**City of Phoenix
Office of the City Engineer
Design and Construction Procurement**

**LIFT STATION 76 PHASE II EXPANSION
WS90400067**

ADDENDUM NO. 2

ISSUE DATE: APRIL 16, 2024

BYPASS PUMPING PLAN

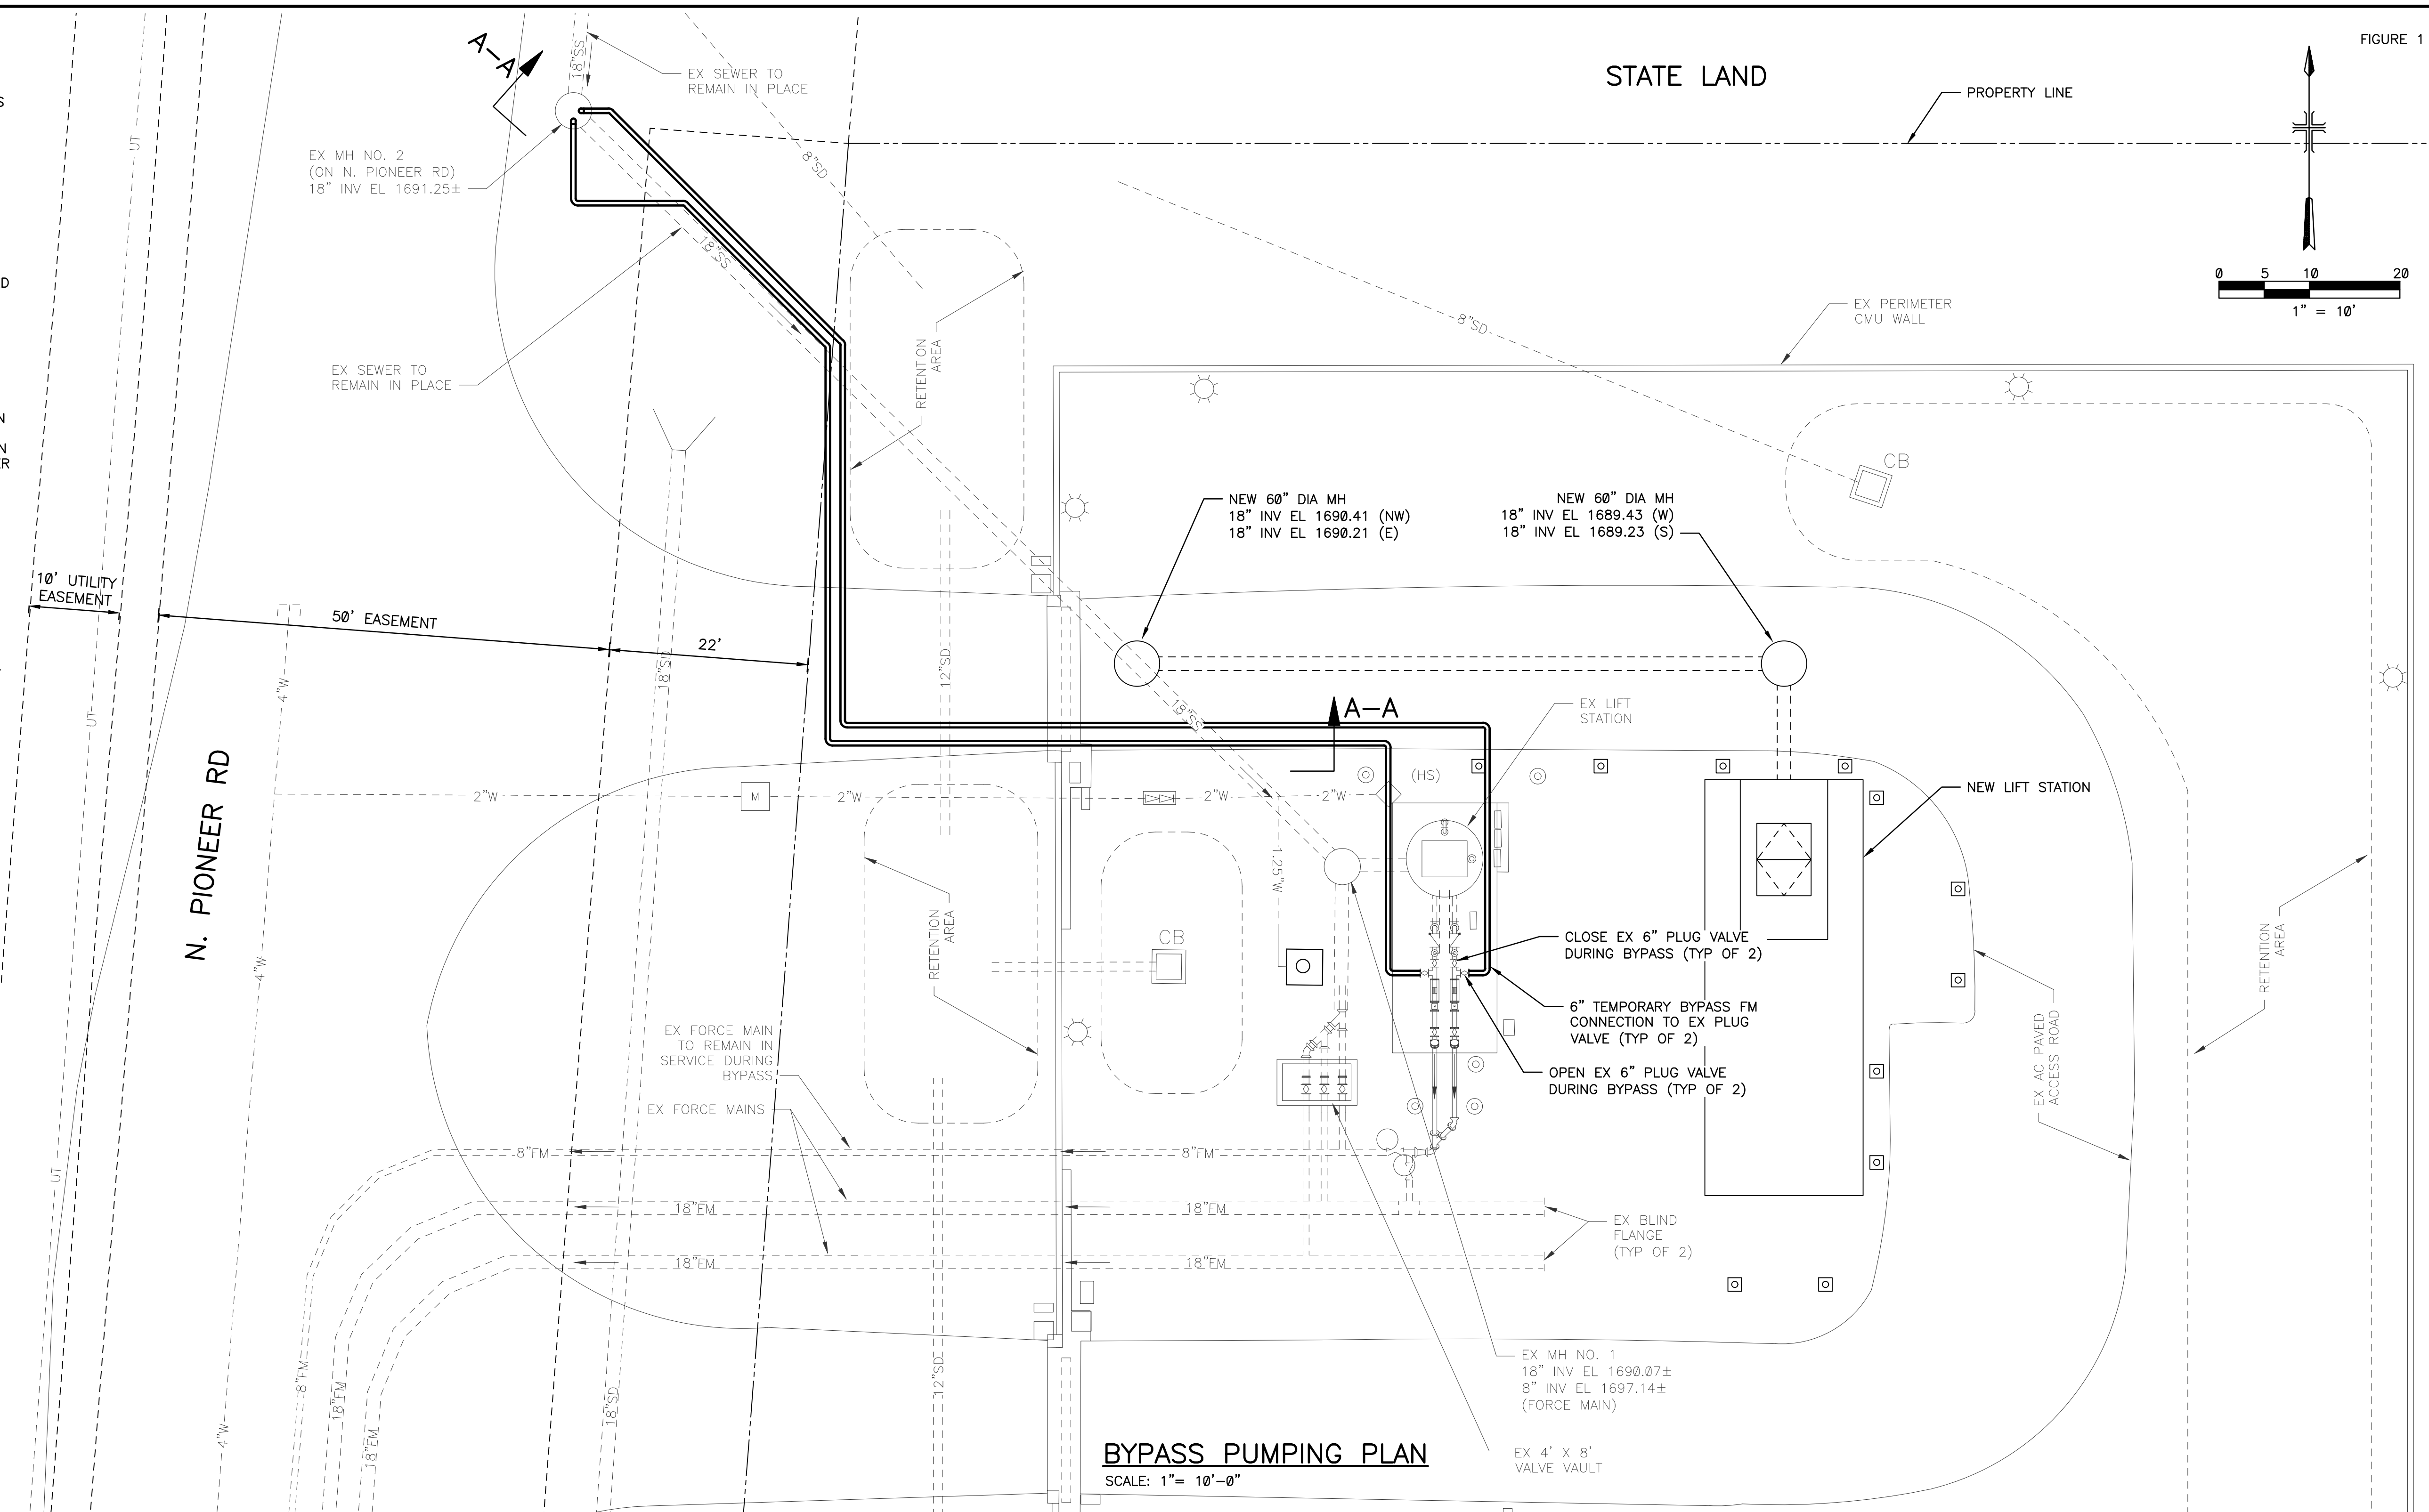
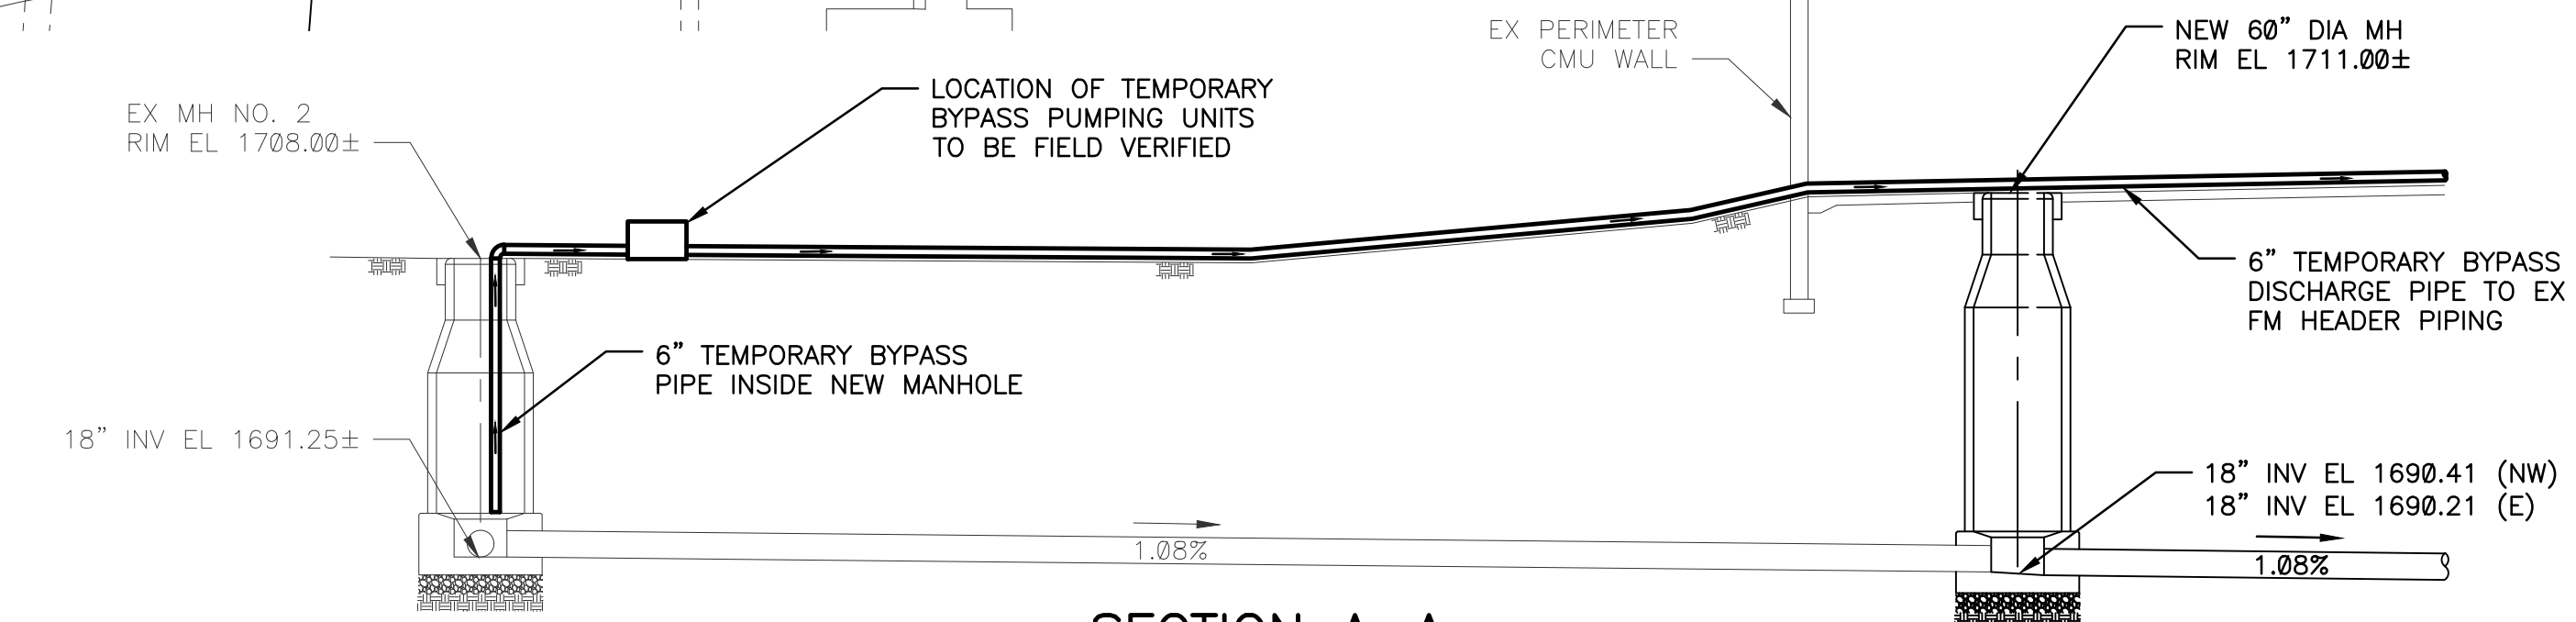
2. **PROJECT TECHNICAL DRAWINGS:** Sheet X01, BYPASS PUMPING PLAN (Sheet 41 of 41), **DELETE** the sheet in it's entirety and **REPLACE** with attached sheet X01, BYPASS PUMPING PLAN.
